MECKLENBURG COUNTY
DEPARTMENT OF ENVIRONMENTAL HEALTH

APPLICATION FOR SOIL INVESTIGATION

SITE INVESTIGATION REPORT
INDIVIDUAL SEPTIC TANK SYSTEM
WITH SUBSURFACE,
SOIL ABSORPTION,
EFFLUENT DISCHARGE

S.I.R. # 16149

* See Diagram on Back (Include: Soil areas, property lines, roads, streams, gullies wet areas, fill areas, wells, water bodies, slope patterns, etc.

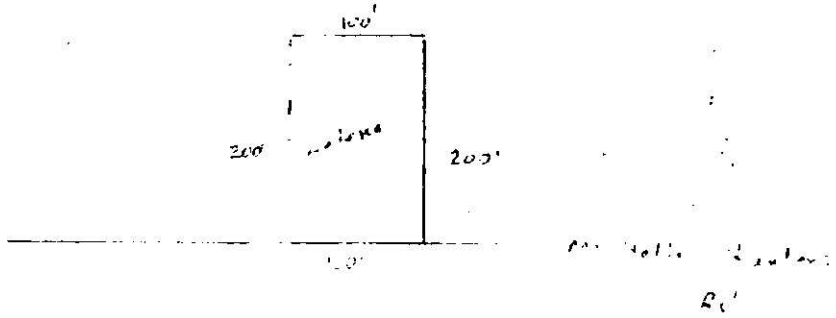
FACTORS	AREA 1	AREA 2	AREA 3	AREA 4
1. SLOPE (%)	S 2 3 6 PS U	S PS U	S PS U	S PS U +
2. SOIL TEXTURE (12-36 in.) (Sandy, loamy, clayey, Note 2:1 Clay)	S sl PS c l U	S PS U	S PS U	S PS U
3. SOIL STRUCTURE (12-36 in.) (Clayey Soils)	S Moderate PS U	S PS U	S PS U	S PS U
4. SOIL DEPTH (In.)	S 48+ PS U	S PS U	S PS U	S PS U
5. RESTRICTIVE HORIZONS (In.) (Impervious Strata Rock)	S None PS U	S PS U	S PS U	S PS U
6. SOIL DRAINAGE/GROUNDWATER (External & internal)	S Seasonal PS Perched Water Table U	S PS U	S PS U	S PS U
7. SOIL PERMEABILITY (Percolation Rate)	S 2 Slow PS U	S PS U	S PS U	S PS U
8. OTHER (Specify)	S PS U	S PS U	S PS U	S PS U
9. SITE CLASSIFICATION	Unsuitable			
SOIL SERIES	Helena
